GARVIES POINT -
PUD AMENDMENT, BLOCKS D/E & F SITE PLAN AND
LOT LINE MODIFICATION APPLICATIONS

CITY OF GLEN COVE PLANNING BOARD MEETING - **CONTINUED PUBLIC HEARING**
NOVEMBER 9, 2023

APPENDIX – APPLICANT RESPONSES TO CONSULTANT MEMOS (9/21/23)

Applicant responses to Nelson + Pope Memorandum dated July 21, 2023 (Received 9/5/23), Cleary Consulting Memorandum dated July 28, 2023 (Received 9/5/23) and Saratoga Associates Memorandum dated July 28, 2023 (Received 8/18/23)

APPENDIX – BLOCK D PARKING CONFIGURATION UPDATE (9/21/23)

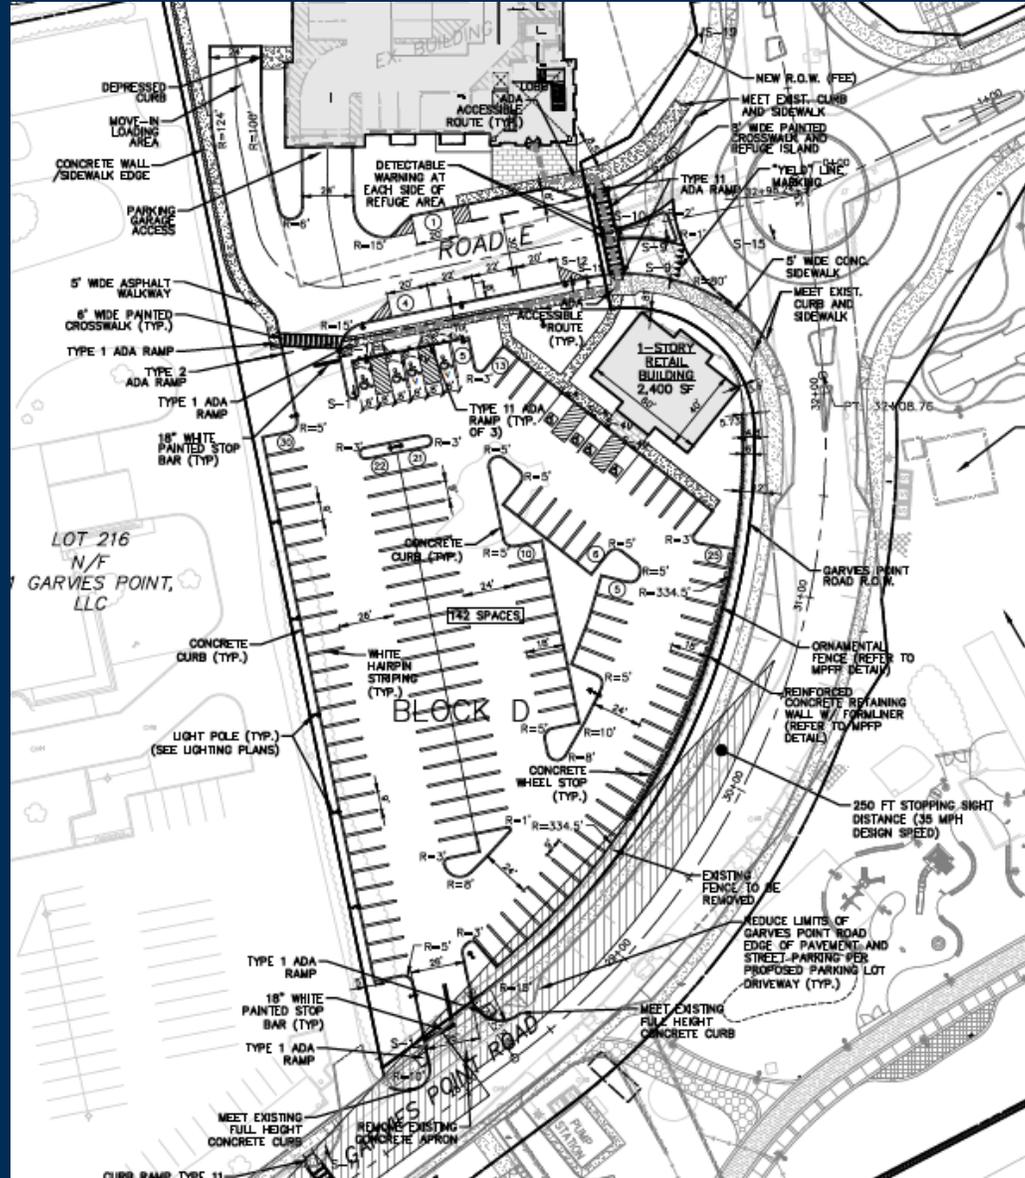
4	Component 3, Block D: In the previous approvals the Board expressed concern about the number of parking stalls that would be available to the public. The current application appears to reduce the parking available to the public in the 2022 approval by approximately 25 stalls.	The 2022 approval included a total of 160 stalls at Block D, of which 93 required for the upscale restaurant and wellness center/spa. The remaining 67 for visitors, ferry parking, etc. This Third PUD Amendment includes 142 stalls at Block D, of which 73 are required for Block E. The remaining 69 for visitors, ferry parking, etc. This Third PUD Amendment provides 2 additional public stalls.
5	Component 3, Block D: The Applicant should clarify the modifications between the previous 2022 approval and the current application.	Parking lot reconfiguration and the addition of the retail kiosk building. Per the Minor Subdivision application package, Blocks D and E are proposed to be merged.

7	II. Block D: Are the 23 off-street parking spaces that are being eliminated being replaced elsewhere within the project?	The 2022 approval included a total of 160 stalls at Block D, of which 93 required for the upscale restaurant and wellness center/spa. The remaining 67 for visitors, ferry parking, etc. This Third PUD Amendment includes 142 stalls at Block D, of which 73 are required for Block E. The remaining 69 for visitors, ferry parking, etc. This Third PUD Amendment provides 2 additional public stalls.
8	II. Block D: Is a tenant for the retail building known?	A tenant is not known at this time.
9	II. Block D: Are any changes to access points to the parking area proposed?	No change.
10	II. Block D: Details of building architecture, landscaping, lighting and signage around the retail building are required, as this is a particularly prominent and visually important location.	The architecture and landscaping of this retail kiosk building will be consistent with and complement the adjacent Garvies Point residential buildings. Following the Planning Board approvals of the Third PUD Amendment, Site Plan and Minor Subdivision applications, a complete permit drawing set will be issued to the City of Glen Cove's building department for review and approval.

11	II. Block D: How will the parking spaces be allocated (private parking, general public parking, ferry parking, etc).	This Third PUD Amendment includes 142 stalls at Block D, of which 73 are required for Block E. The remaining 69 for visitors, ferry parking, etc. The 73 stalls closest to the Block E building will be reserved for the Block E residents. The remaining 69 stalls will be allocated to Block E building visitors, Garvies Point visitors, ferry parking, etc and the Applicant will work closely with the City of Glen Cove.
12	II. Block E: Clarify that the unit mix continues to conform to the density thresholds previously approved.	The Block E unit mix is comprised of 12 - studios, 35 - 1 bedrooms, 46 - 2 bedrooms and 8 - 3 bedrooms; total 101 units. Reference Drawing CC.10 Building & Unit Matrix as prepared by BHC Architects included in this application.
13	II. Block E: Will the restaurant and spa used be replaced elsewhere within the project?	The restaurant at Block A remains in the Project. The addition of the retail kiosk building at Block D is included in this Third PUD Amendment and Site Plan applications.

APPENDIX – BLOCK D PARKING SITE PLAN UPDATE (10/19/23)

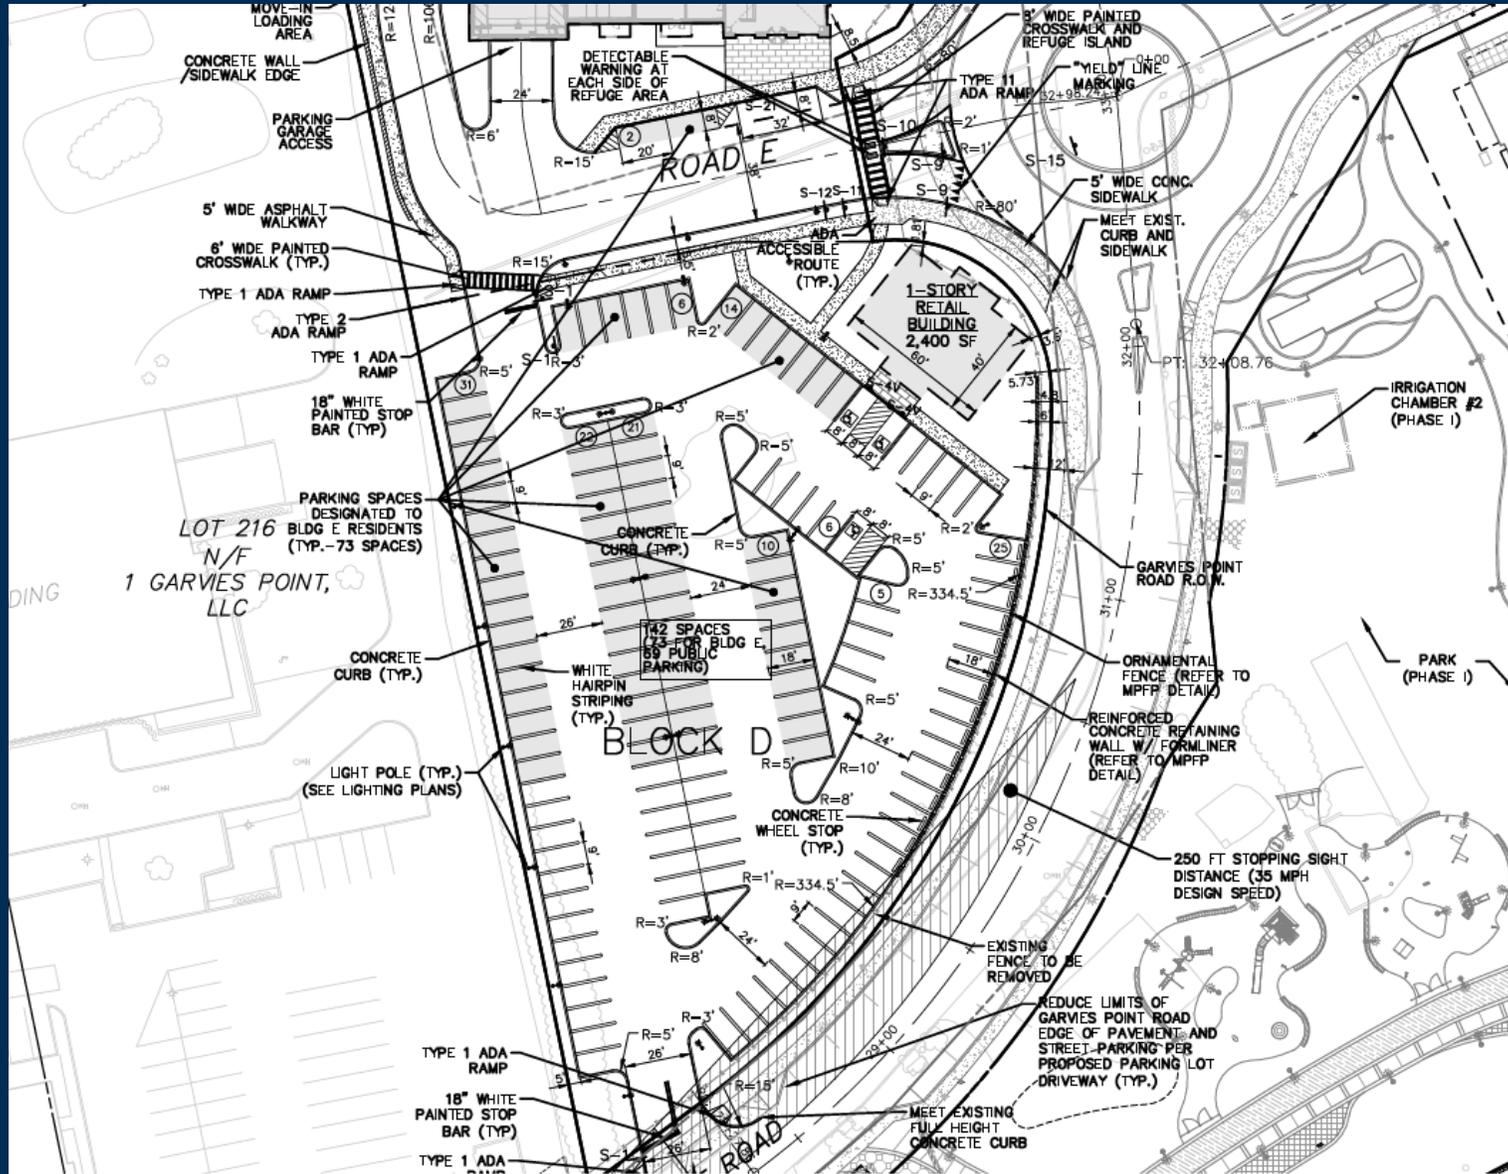
B.1	Blk D and E Parking: a. While the revised Blk D and E driveway parking configuration eliminates the stalls situated in the Blk D entrance driveway aisles, reconfiguration to include parking on the southside of Road E creates potential vehicular conflicts within Road E, the Building E garage and service driveways, and the Road E intersection with the roundabout. These two stalls should be relocated. N+P and the Applicant's Engineer have been in communication regarding the parking lot reconfiguration, and we anticipate a satisfactory solution to be presented in the next resubmission for the Board's consideration. b. Section 1106 of the NYS Building Code states that where there is more than one parking facility, the number of required handicap parking stall shall be computed separately. The Blk D parking lot has stalls allocated for "public use" and stalls allocated for the residents of Blk E. The number of handicap parking stall provided in the Blk D parking lot and the Blk E garage shall not be less than the computed required amount as computer under Sections 1106.1 and 1106.2 (Residential Occupancy R-2). N+P recommends the Applicant and their Engineer review the handicap parking computation as it may assist in the elimination of the southside Road E parking.	Reference attached revised Drawing C1.05 Site Plan dated 10/10/23 prepared by PS&S.

APPENDIX – BLOCK E LANDSCAPING RAIN GARDEN UPDATE (10/19/23)

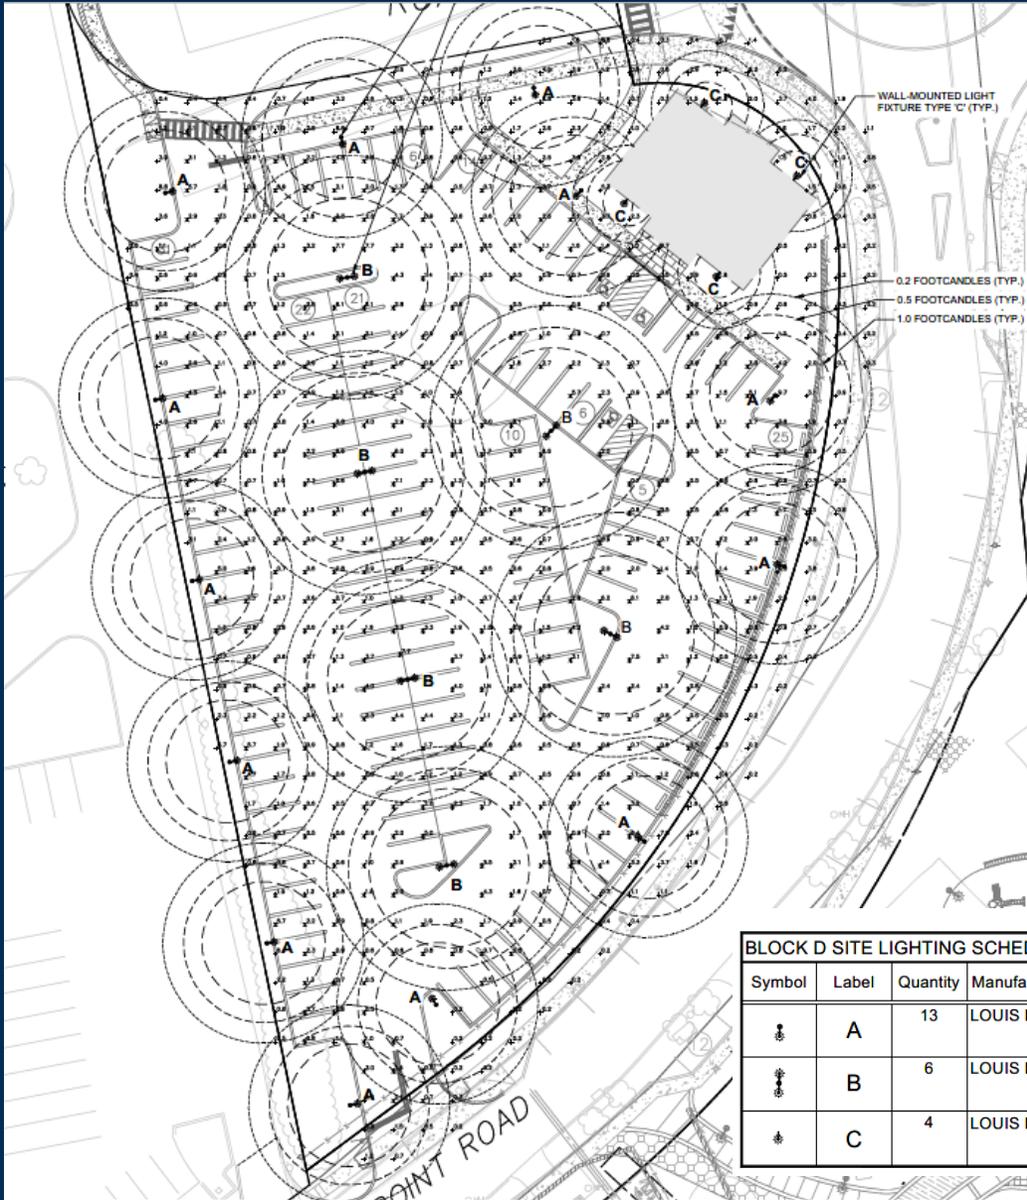
B.3	Blk E Rain Garden - Detail & Planting Plan: a. N+P recommends the rain garden planting schedule be revised as follows: i. Rudbeckia hirta is a short-lived plant, replace with a longer living one like Rudbeckia fulgida, ii. Panicum amarum is a dune grass and very aggressive, replace with Panicum virgatum cultivar that will not spread like Shenandoah or Orient or other, iii. Euonymus kiautschovicus is being considered for the invasive list, please replace it with another plant. b. There appears to be an area in the middle of the rain garden that is not planted. Appropriate native planting should be added to the unvegetated area as the area is intended to be "dry" except during rain fall events.	Reference attached Drawing L1.03 Landscaping - West Plan dated 10/16/23 prepared by Steven Dubner Landscaping, Inc. The planting schedule and rain garden layout have been updated accordingly.
B.4	Blk D Site Area Lighting: a. Provide site lighting intensity distribution plan.	Reference attached Drawing C1.08A Lighting Plan dated 10/13/23 prepared by PS&S.

APPENDIX – BLOCK F PARKING LEVEL PLAN UPDATE (10/19/23)

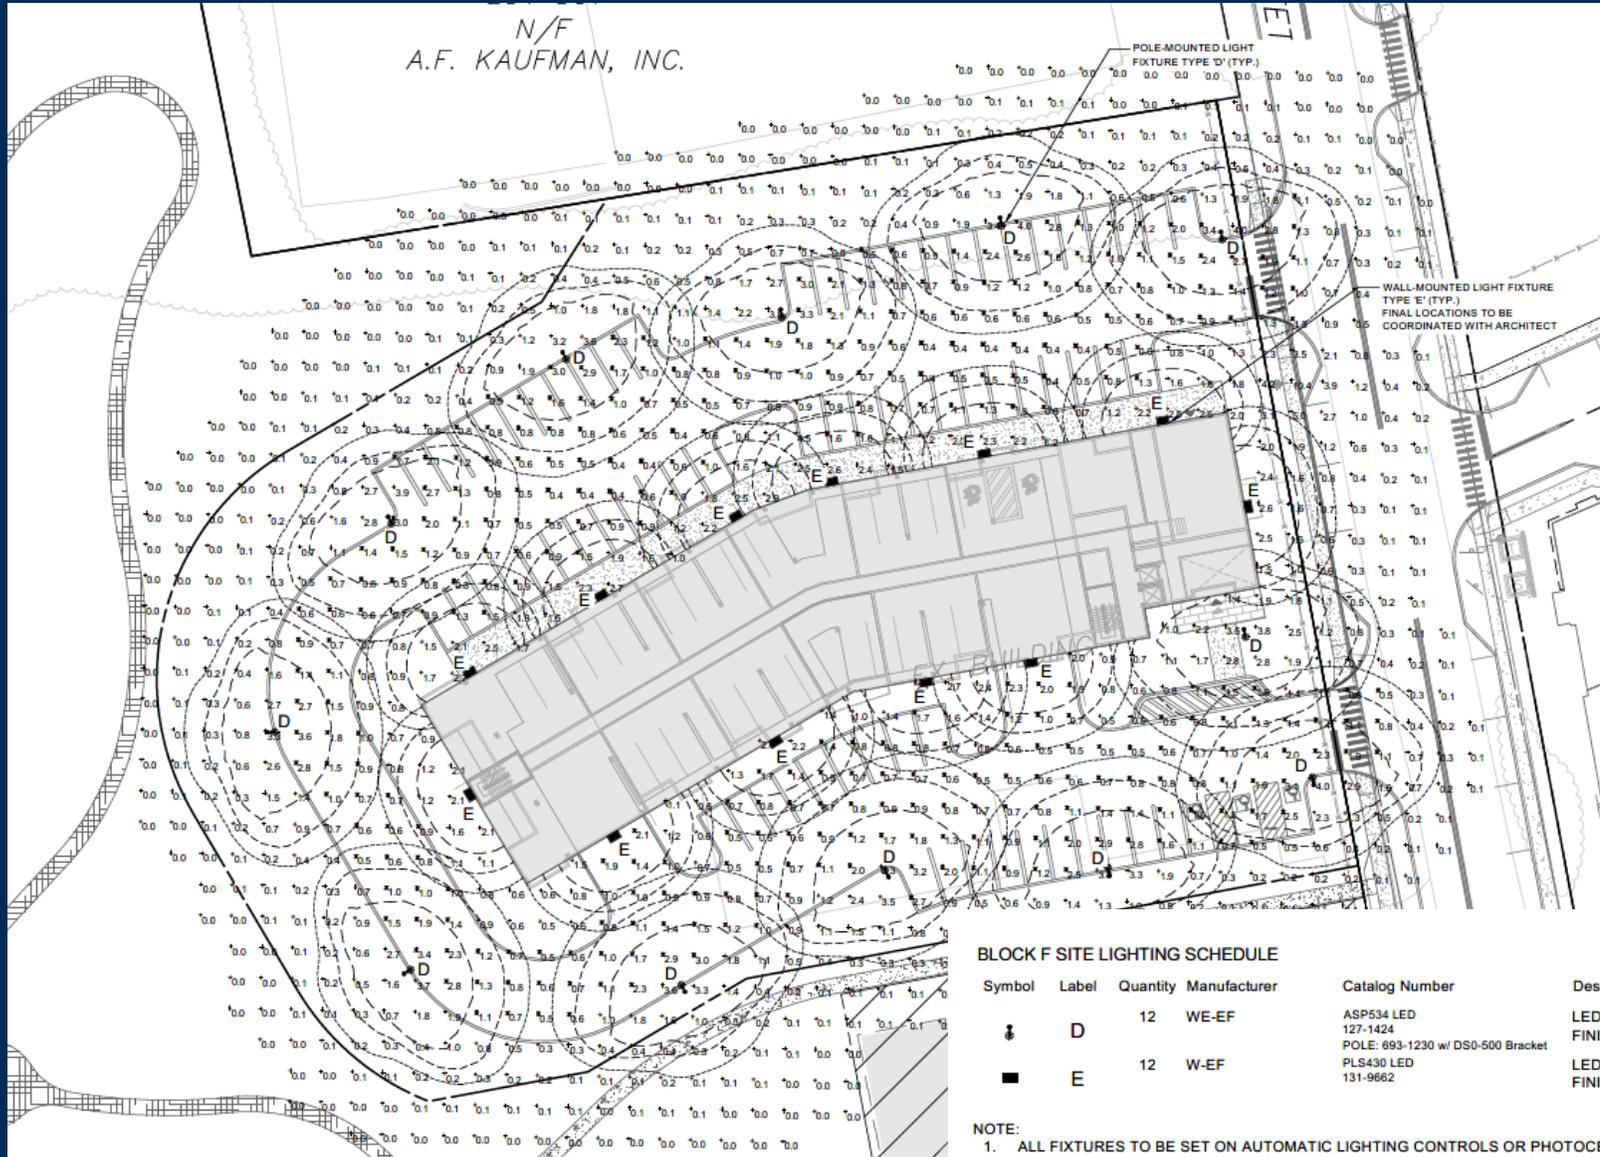
C. 1	Blk F Parking: a. No Handicap stalls are shown in the garage. Please review the NYS Building Code Handicap parking requirements and location to confirm if handicap stalls (van accessible) are required in both the garage parking area and the outdoor parking area. If required to be distributed between the two parking areas, please distribute accordingly.	BHC has confirmed that two handicap stalls are required in the garage. Reference attached revised Drawing 01 dated 2023.10.10 prepared by BHC.
C.2	Blk F Utility Plan: a. Confirm that the horizontal and vertical clearances, including sanitary and water comply with NCDPW and NCHD requirements.	PS&S has confirmed the Drawings and notes comply with NCDPW and NCHD requirements.
C.3	Blk F Site Area Lighting: a. Provide site lighting intensity distribution plan.	Reference attached Drawing C1.08A Lighting Plan Building F dated 10/13/23 prepared by PS&S.
